RE: Fedinec Pit, Permit No. M-1977-057, Unresolved Problem(s) Noted in a Past Inspection Report

COLORADO DIVISION OF RECLAMATION, MINING AND SAFETY MINERALS PROGRAM INSPECTION REPORT

MINE NAME:	MINE/PROSPECTING ID#:	MINERAL: COUNTY:	
Fedinec Pit	M-1977-057	Crushed stone materi Moffat	
INSPECTION TYPE:	INSPECTOR(S):	INSP. DATE: INSP. TIME:	
Monitoring	Amy C. Yeldell	May 10, 2016 12:00	
OPERATOR:	OPERATOR REPRESENTATIVE:	TYPE OF OPERATION:	
Pioneer Sand Company, Inc.	Wayne Brantley	110c - Construction Limited Impact

Existing Contours

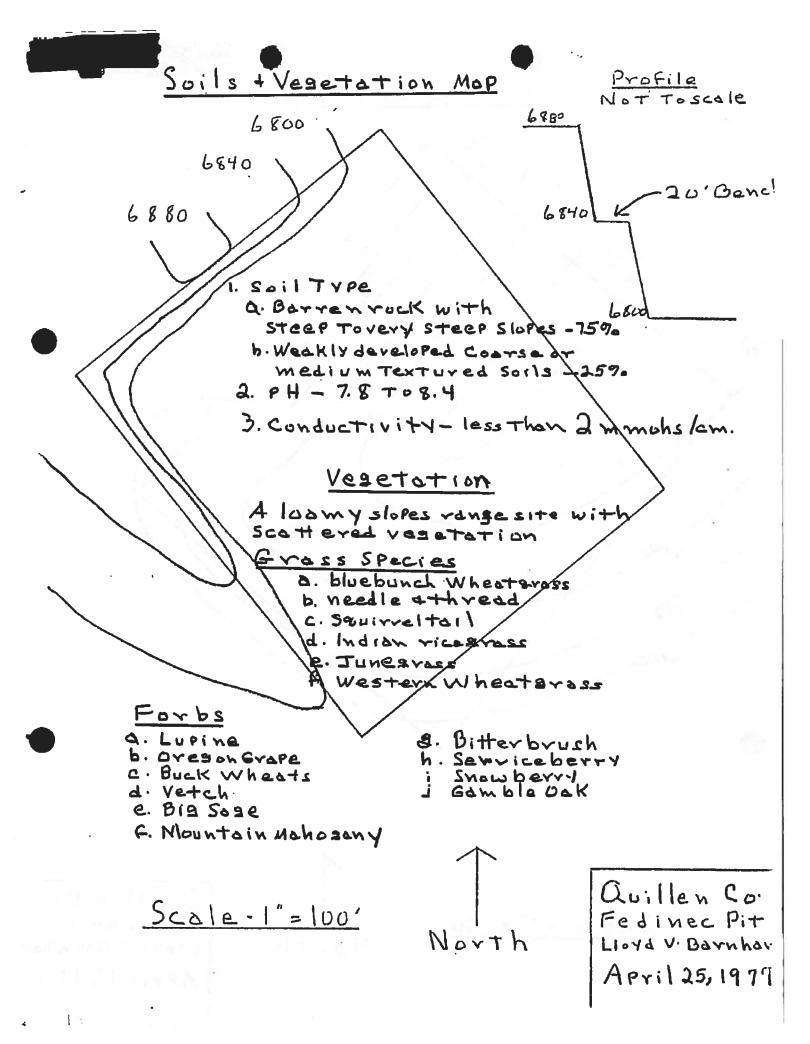
999
	The state of the s
	Contractor Federal Pil File # 77.57
	Civil Metrica
500 × 430	Map & Cicreacy
100:60	Index Hap shows "private acceso &
-	a much exaginated pit area. The other
	imapo show 5 acres which are applied
	for but don't show any access on any
	reference to tell where in the Square on
	the index map the per augus be I really
<u> </u>	don't think its ok. Road providing about the
	Demnitte da known urberence put on map
N -0	Three of
	Legal may not be right or rather index map
the majorate and the second	may not be right of don't think it shows.
	TION PROW- Caristell.
	grand to refer the file of the second framework to be a first
74 74	Mining Plan - the reference to 80° slopes from
	Colo Mining laws is for oak working
	Conditions-not ideal vulamation clopes

- NA	Plan is really wague
	\$1 where is topsoil stockpiled? within
	5 acres!
<u> </u>	#3 describes final configuration but not
	how it will be achieved.
	44- how do they open for ?- how do being
1	remove material?- do there blasting?
h	If so how about starage for Clasting
	materials?
	-the "nearly wertical face" described on

- 1 th	NE corner are only 100:60 on the
	Existing Contours Mas - is: No where
	mean wentical although steep.
10.00.0	who there examplians on site. ? Lease must theme
in which	The state of the s

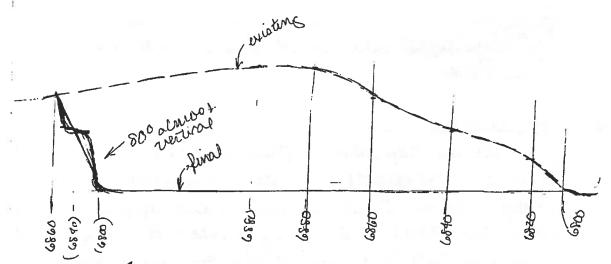
This is cross section through EN diagonal of area. Max slopes must be compatible with configuration of our ounding Conditions & selected land use. (cattle grazing). Is it reasonable to take hilly area & pur in vertical walls & flot brase & call it compatible? Maybe a ling like the red one would be more acceptable. They'd have to remove less material or import backfill. If quantity is a problem they could take a linger area - is dacres & get the same amount.

RecPlan: Bench should be oloped to retain moisture? If road is included - get new plan for.
